Flight Procedure Tracking Form		Action: FLIGHT CHECK	Task Type: IAP	Date Open: 07/14/2015	Task #: 2015071432933001003	Request #: 20150714329330
Procedure: NDB RWY 32 AMDT 1			Airport ID: PASD	Airport: SAND POINT		Reimbursable #: NO
City: SAND POINT	ST: AK	GPS #:	Estimated Chart Date: 03/29/2018		FICO #:	
Fac ID: HBT		Fac. Type: NDB			Specialist: HERMAN ROGERS	
Procedure Review						
	Rec'd	Rel'd	Full Name	Comments		
Lead:	08/30/2017	11/15/2017	ADOLFO URRUTIA	QUALITY		
QA:	11/15/2017			4 12/22CTabaka		
Liaison:				CHECKED		
Procedure Comments:			Remark Type: INFORMATION			
<p>ENROUTE-NON</p> <p>ESV(S): 1, LOA(S): 1</p> <p>MAGVAR UPDATE PENDING DATA USED FOR PASD AIRPORT AND BORLAND (HBT) NDB</p> <p>ASSIGNED MAGVAR: PASD/HBT NDB OLD 15E/2005-NEW 11E/2020</p> <p>CONTACT: PAT MULQUEEN/ADOLFO URRUTIA AJV-543 405.954.4073/2079</p>

Subject: **ACTION:** Approval Request

NDB RWY 32, Sand Point, Sand Point, AK (PASD)

NDB/DME RWY 32
SAND POINT (SDP) (PASD)

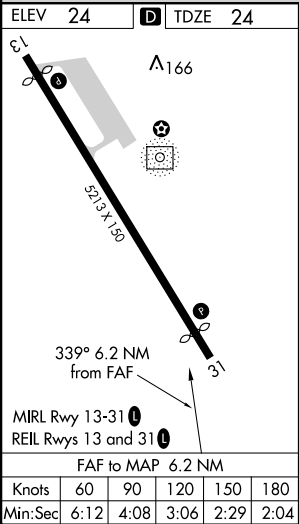
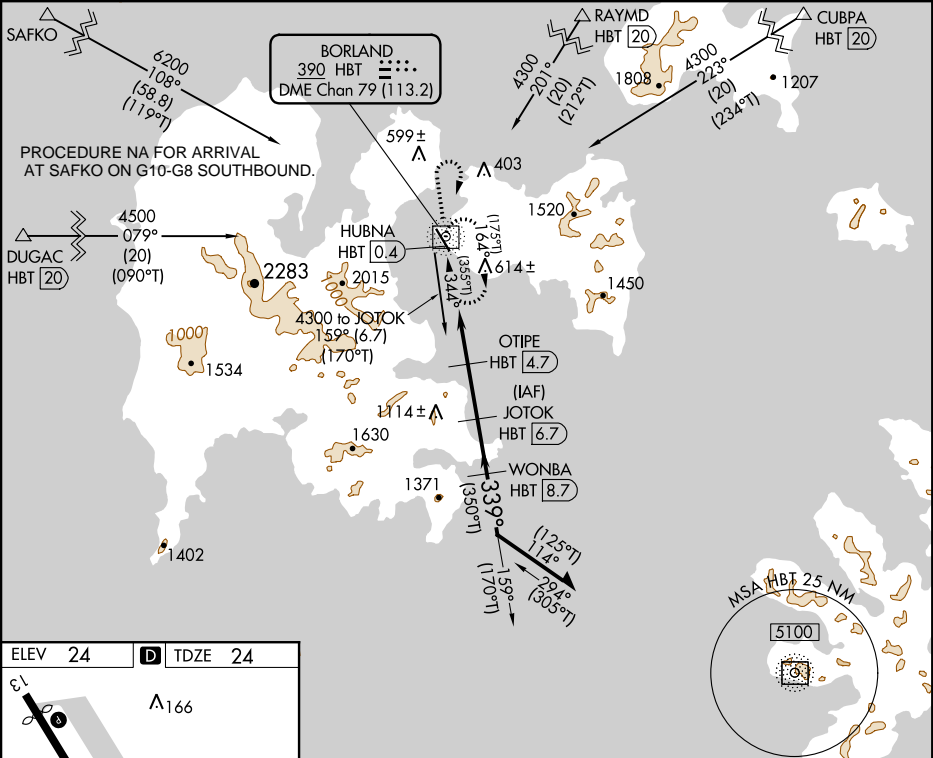
FAAO 8260.3C, VOL 1, PARA 2-6-2. Glidepath Angle (GPA) and Vertical Descent Angle (VDA). b. Flight Standards approval is required to establish a VDA (of a procedure where the FAC is straight-in aligned) that is less than the angle of a VGSI installed to the same runway. d. VDAs must not exceed the values specified in table 2-6-2.

The NDB RWY 32 is a non-precision straight-in aligned approach with CAT A-D minima. The procedure VDA is 3.47 and TCH is 36. The TCH meets the minimum glidepath-to-wheel height for height group 1. The VGSI for Rwy 32 is aimed at 3.60 degrees and TCH of 36.0. Increasing the procedure VDA to match the VGSI angle of 3.60 degrees would exceed the maximum allowable VDA for Cat D aircraft of 3.50 degrees. The procedure will be published with the following chart note: VGSI AND DESCENT ANGLES NOT COINCIDENT (VGSI ANGLE {ANGLE} TCH {FEET}). Request approval to use a 3.47 degree VDA for the NDB RWY 32 procedure.
